# **Impact of Groundwater Contamination in East Multnomah County on the Interlachen Community**

**Technical Report EWR-3-96**  
**Department of Civil Engineering**

**Prepared for Friends of Fairview and Blue Lake under support of the U.S. Environmental Protection Agency TAG Program**

The Friends of Blue and Fairview Lake through the Environmental Protection Agency (EPA) Technical Assistance Grant (TAG) program contracted with Portland State University faculty and staff to provide an independent review of the groundwater contamination problem at the Boeing-Cascade site in East Multnomah County. An independent consultant, Karann Brandt, of PRC Environmental Management, Inc., was also assisting the panel with the review.

**Figure 9: Remediation plan for the TSA cleanup (DEQ, 1996).**

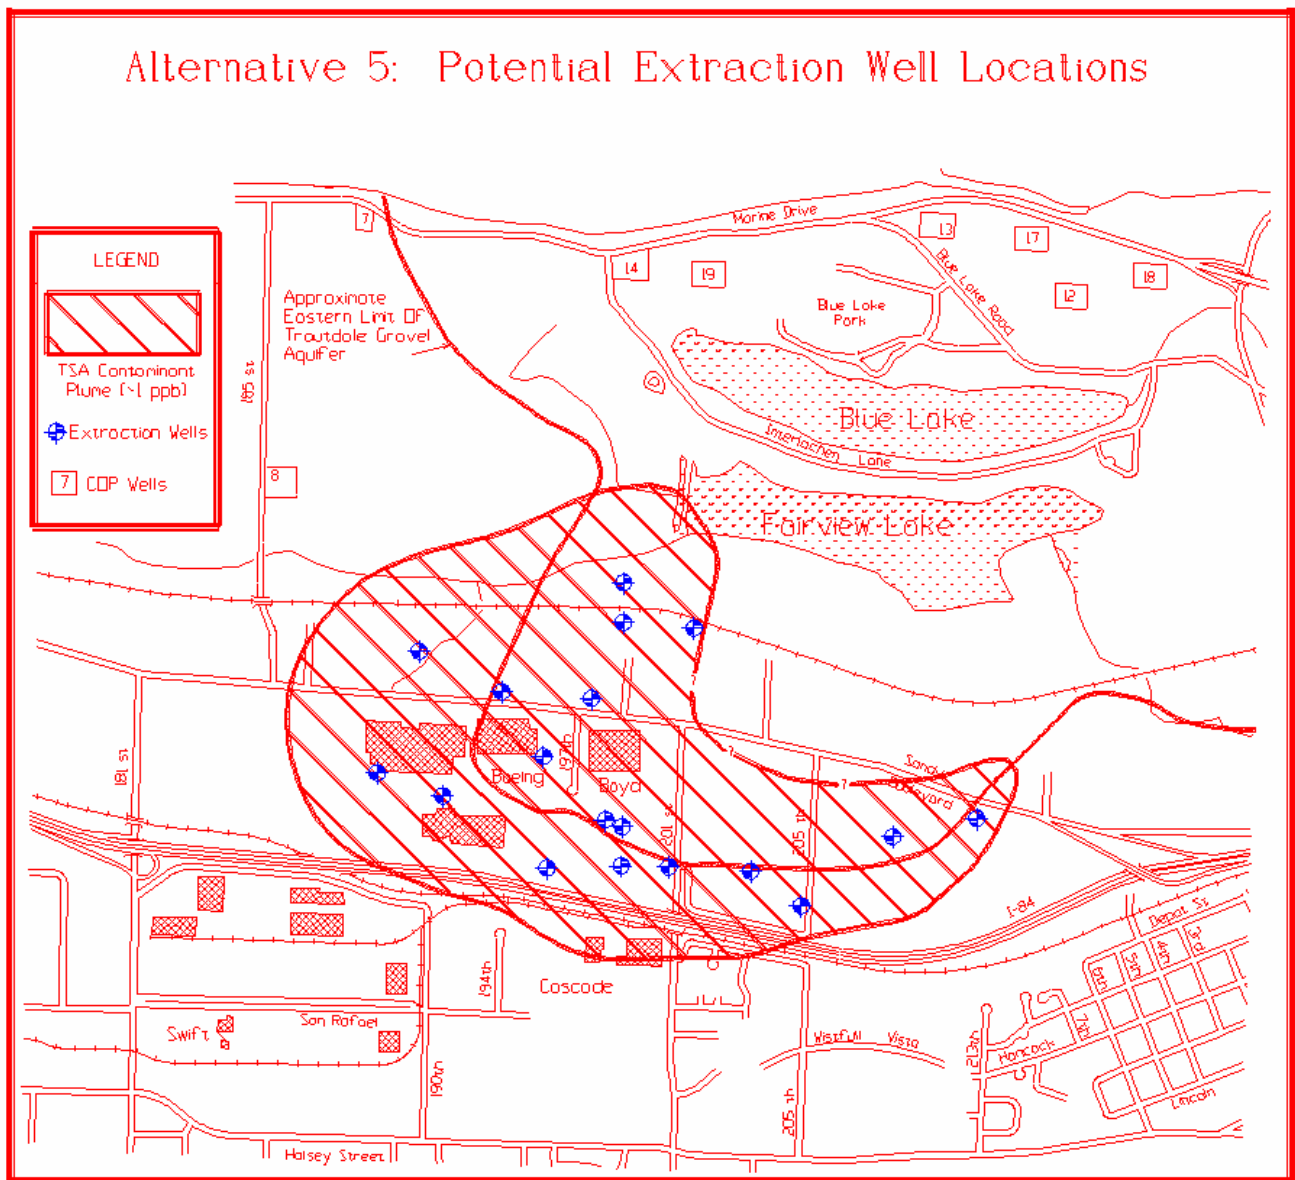
- Monitoring for Chromium and other known heavy metal contaminants should be required for treated effluents from the TGA remediation effort at Cascade and plans for heavy metal removal prior to discharge into nearby surface waters should be developed

Current on-site and off-site remediation of the TGA plume around Cascade has focused on removal of volatile organic compounds and their treatment through air-stripping towers. The current and proposed pump-and-treat systems discharge their effluent, after air-stripping, to the nearby storm drains that travel to Osbourne Creek and into Fairview Lake, or into Storm Drain Creek and into the Upper Columbia Slough. Heavy metals are not monitored even though the areas of remediation were known to have heavy metal contamination. There is a need to add heavy metals to the list of monitoring requirements and to prepare a contingency plan for removal of heavy metals if found in the effluents. Also, the loading of heavy metals to Fairview Lake and the Upper Columbia Slough may be restricted because of the Total Maximum Daily Load (TMDL) requirements currently being determined by DEQ. The present and future loading of heavy metals to nearby surface waters should be estimated, and this information should then be given to the Columbia Slough TMDL committee for evaluation.

- Inhalation of volatile organics from pump-and-treat facilities needs to be re-evaluated to determine if a public health risk exists under the proposed remediation plan

The impact of the proposed remediation plan in the Boeing-Cascade area has not been formally evaluated by DEQ for inhalation risk from the air-stripping towers. The proposed remediation plan calls for dozens and dozens of new pump-and-treat wells, increasing the magnitude of the remediation effort by from 3 to 10 times above current levels. Because of the proximity of the treatment facilities to residential areas, guidelines should be proposed by DEQ to ensure that there are no air quality risks. DEQ admitted at a September 4, 1996 public meeting that they have not formally evaluated the inhalation risk of the remediation plans. The Boeing TGA remediation plan, which has not been submitted for public review, also needs to have this level of scrutiny.

This panel agrees that the proposed remediation plan is a correct approach to solving the groundwater problem in East Multnomah County and wants the implementation to proceed as fast as possible. But a clear plan by DEQ needs to be made as to what will trigger more aggressive remediation techniques. For example, the following questions need to be spelled out clearly in the DEQ Record of Decision:

- How will DEQ assess if the remediation plan is working ?
- What if the time frame for remediation seems to have lagged behind the proposed schedule, what steps will be taken, by whom, and when?
- What plans will be initiated if SGA contamination occurs, and what is the level of SGA contamination at which additional remediation steps will be started ?
- If injection for the TSA is proposed (which DEQ assumed would be the next logical step for remediation), has there been thought given to the following issues:
  - if oxygenated water (either from surface sources or recycling from air-stripping towers) were injected into the TSA, there could be both permeability (the vitric sandstone will oxidize and become more and more clogged to flow) and toxicity (TCE can now degrade to the more-toxic vinyl chloride in an aerobic environment) impacts
